# Proposed Sand and Gravel Extraction, Haddiscoe, Norfolk

## Review of Dust Assessment

Date : 12 December 2023

**MICHAEL BULL  
& ASSOCIATES**

Figure 8 Wind field model output - south westerly winds, 5m/s

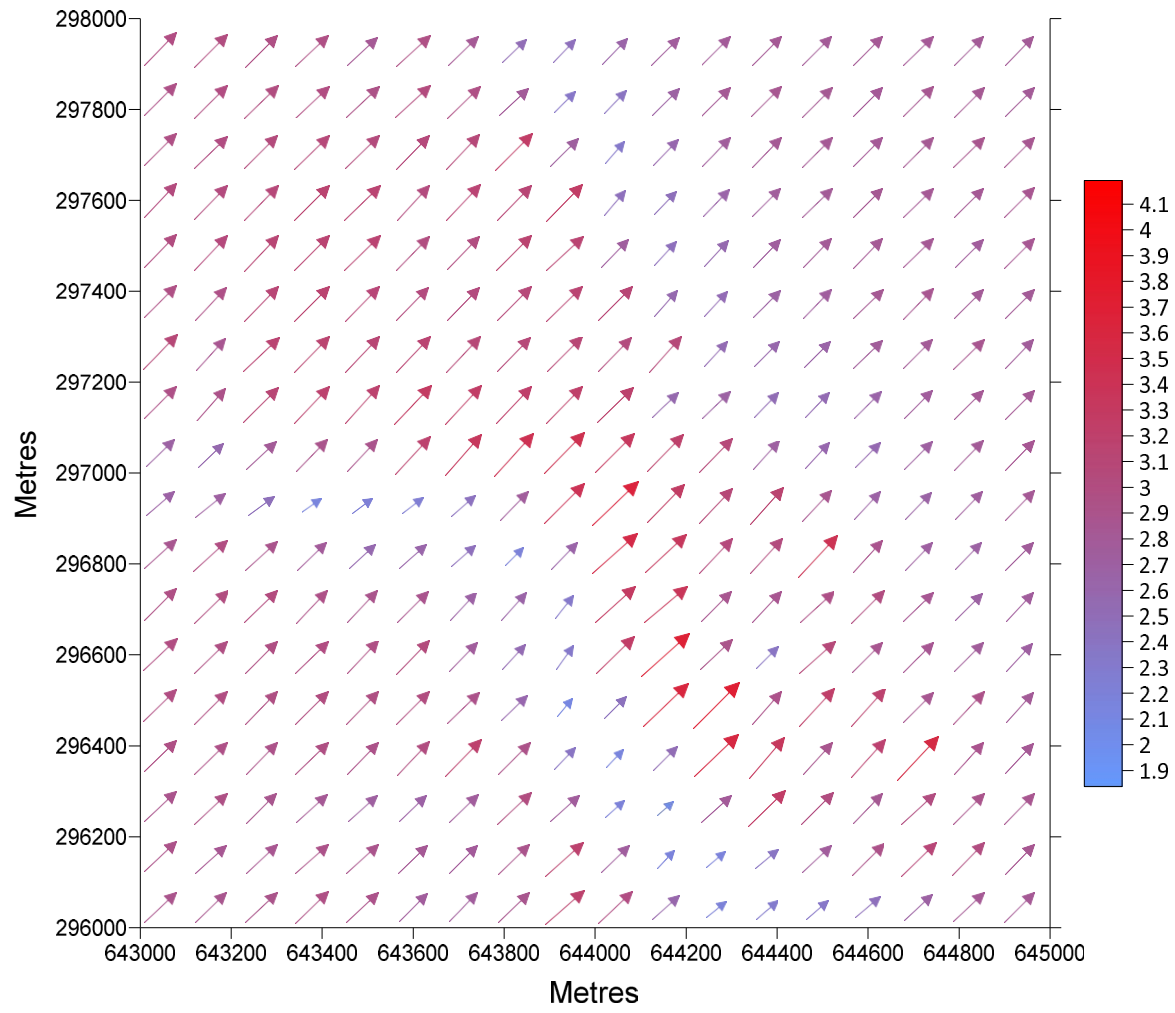
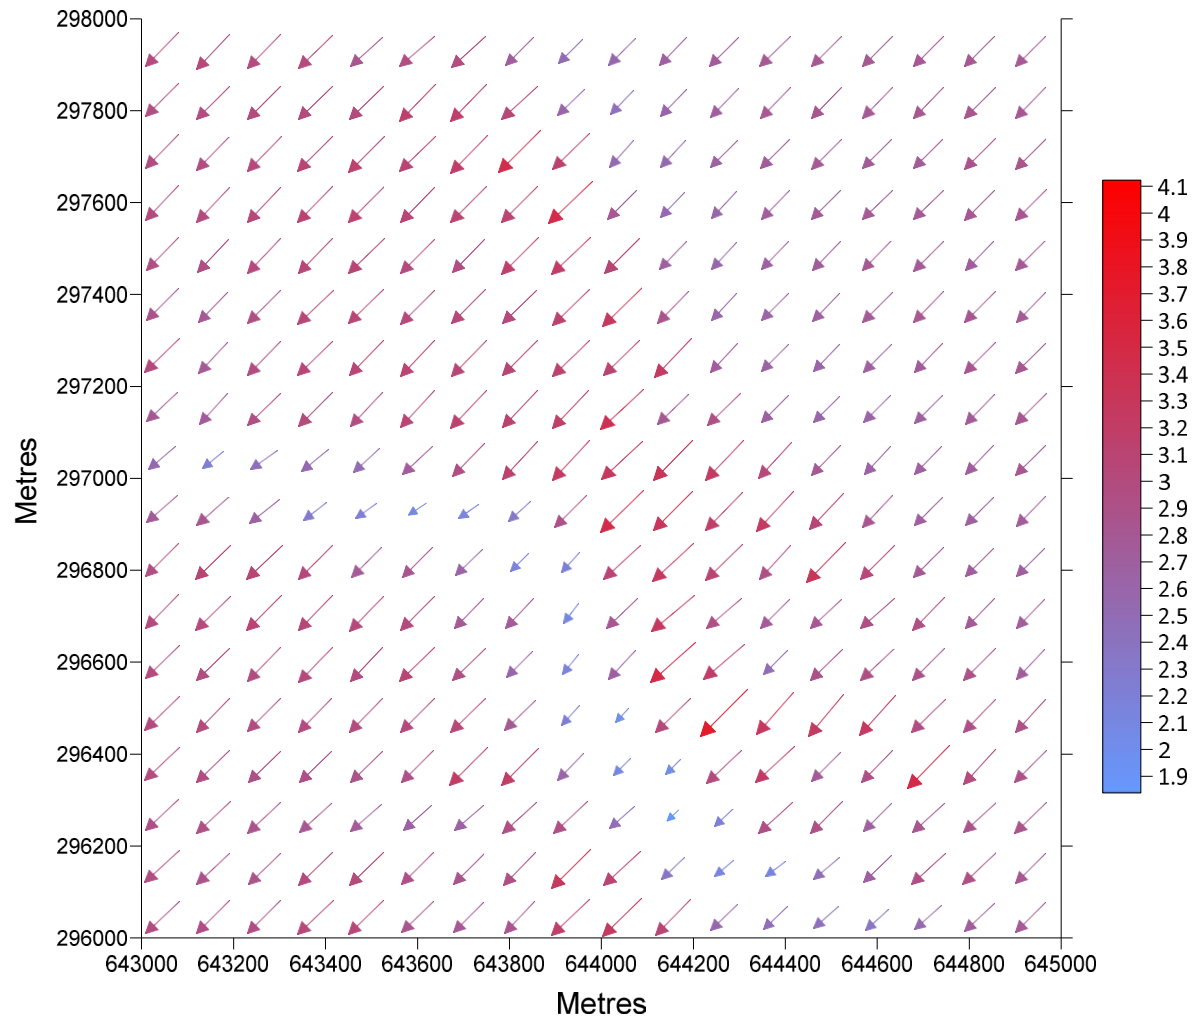
This can be seen using the ADMS model which includes a wind field model that calculates the wind speed and direction at every point within the model domain. To illustrate the possible changes, the ADMS model has been run for two single weather conditions, south westerly winds and north easterly winds at 5 m/s (a typical wind speed for the UK). As can be seen from the results in Figures 8 and 9, the terrain results in changes in wind speed, and to a limited extent, changes in wind direction.

Figure 11 Annual Mean Particulate Concentrations ( $\mu\text{g}/\text{m}^3$ ) Phase 5 - with terrain

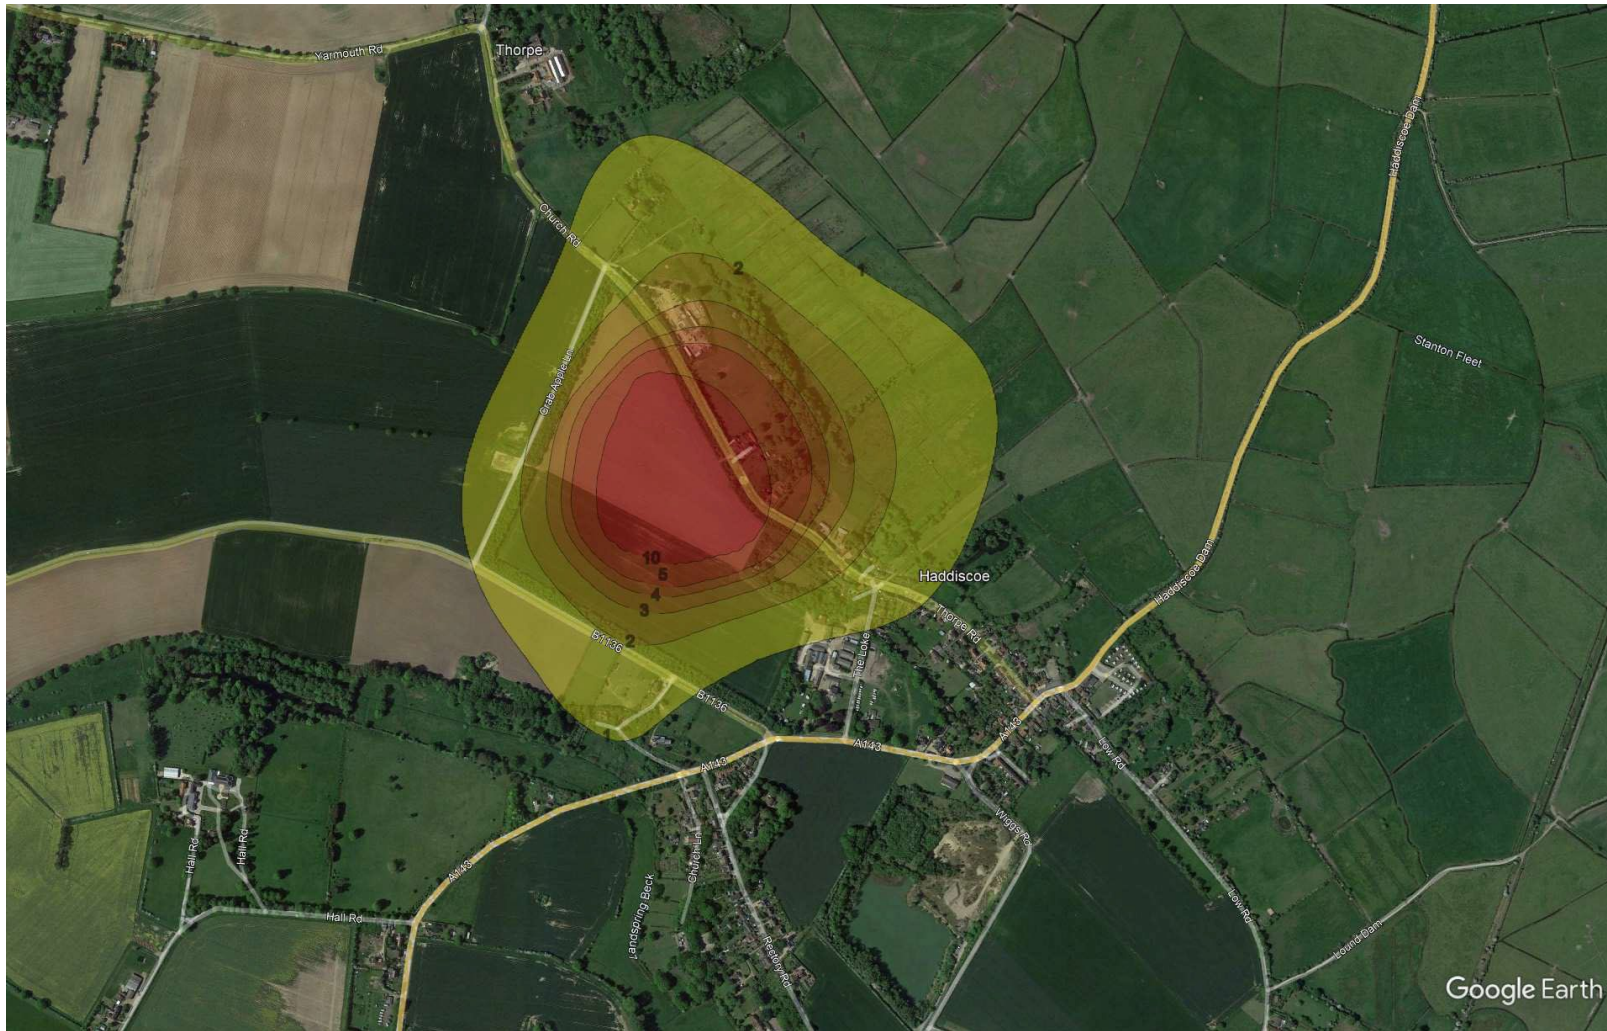
The impact on these changes on predicted concentrations can be assessed with the ADMS model. The model has been rerun including the terrain data for the same cases (i.e. Phase 4 and 5) assessed in Section 5.1, the results are shown in Figures 10 and 11. As can be seen, the inclusion of terrain into the modelling changes the shape and extent of the area affected indicating that it is an important factor to take into account in the modelling.

Figure 12 Wind Rose for Norwich 2020

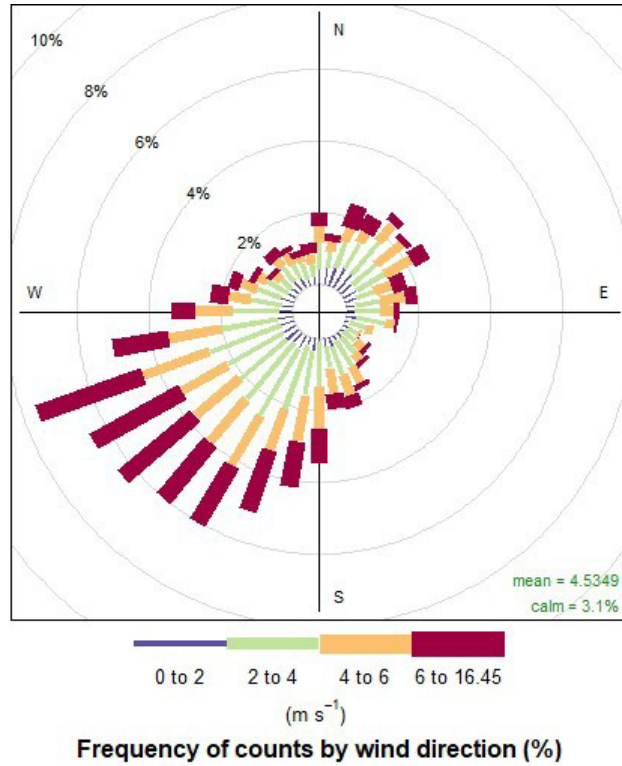
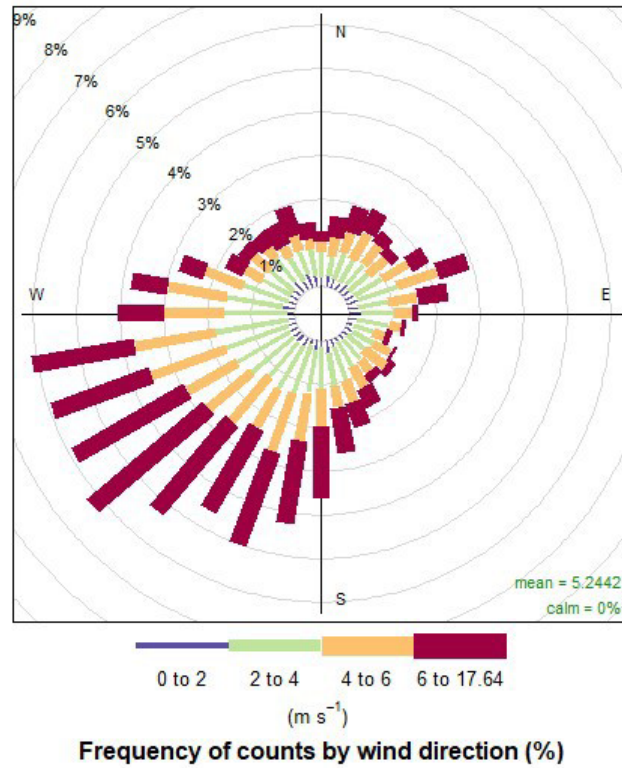
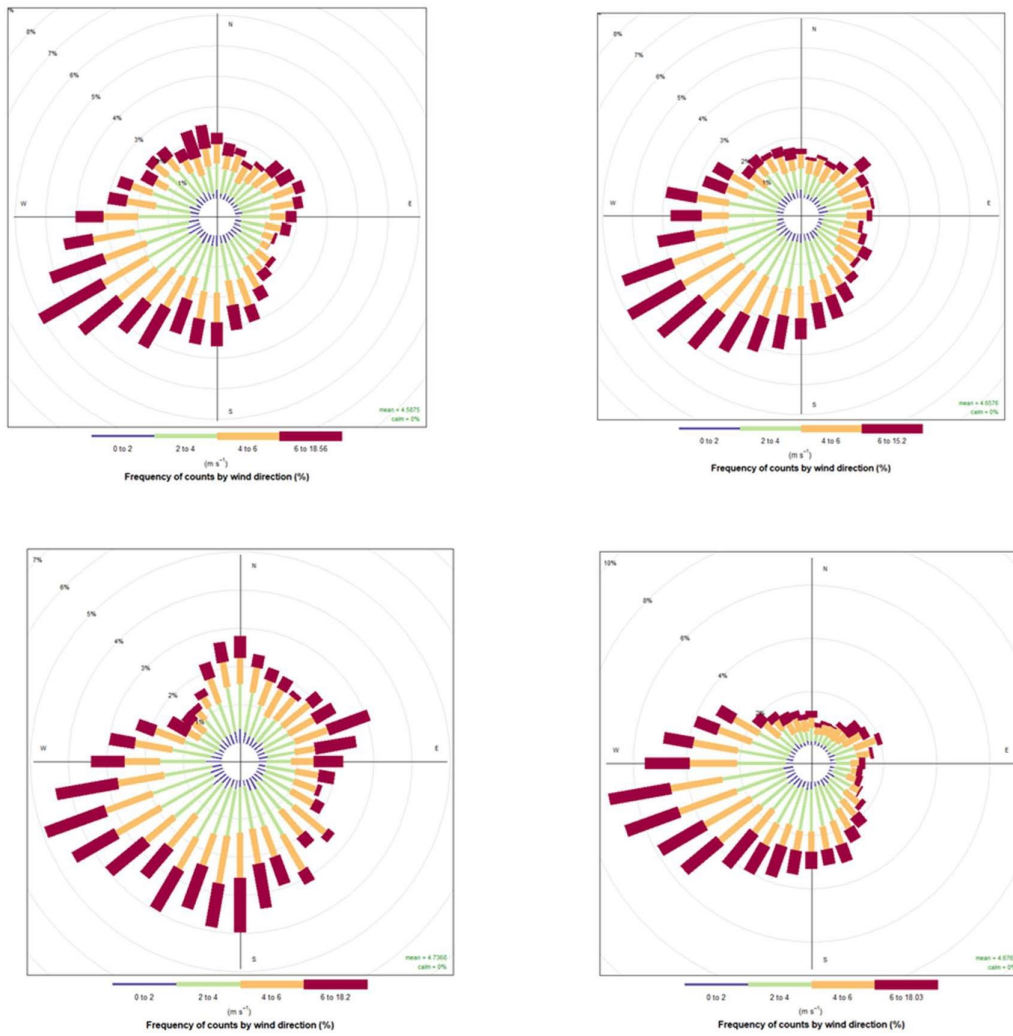
The assessment in the Environmental Statement has used meteorological data from Norwich. This is approximately 28 km from the site and located further inland and the wind rose is shown in Figure 12 for the year 2020. This has been compared with the site specific rose for Haddiscoe for 2020 which is shown in Figure 13 and for the years individual years of 2016-2019 in Figure 14.

As can be seen, although there are overall similarities between the Norwich and the Haddiscoe data, there are considerable inter year differences between the five years of data available. This is why guidance on assessment suggests that you use 3-5 years of meteorological data and select the worst case year. Taking a long term average, as has been done in the Environmental Statement will average out the individual differences between years and hence may results in an underestimate of the impacts.
